Electric Vehicle Charging Hub & Coffee Drive Through, Applegreen Rathcoole

Stage 1 Road Safety Audit

Petrogas Group Ltd

February 2021

Figure 2.1 – Desire Line to Building Entrance

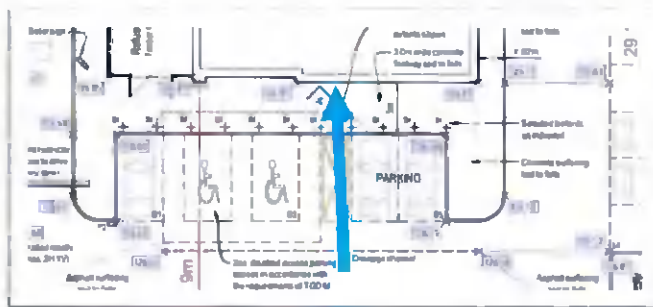
2.3 Problem: Building Access Blocked

Location: Drive Through Coffee Building

Careless parking practice could lead to the main access of the building entrance being blocked, resulting in progression issues for the visually impaired, ambulant disabled or parents pushing prams.

The yellow box should be replaced with a kerbed build-out. The buildout should be aligned centrally with the main access door and should also provide for universal access.

Problem Reference (Section 2)	Designer Response Section			Audit Team Response Section
	Problem Accepted (yes / no)	Recommended Measure Accepted (yes / no)	Alternative Measures or Comments	Alternative Measures Accepted (yes / no)
2.1	Yes	Yes		
2.2	Yes	Yes		
2.3	No	No	Will manage risk with bollards and active site management of parking. Introduction of kerbing would cause trip hazard. Gentle sloped approach in place to main entrance.	Yes
2.4	Yes	Yes		
2.5	Yes	No	Vehicles will be travelling at low speed. Masonry constructed boundary wall will contain vehicle. Signage will be in place to limit speed.	Yes
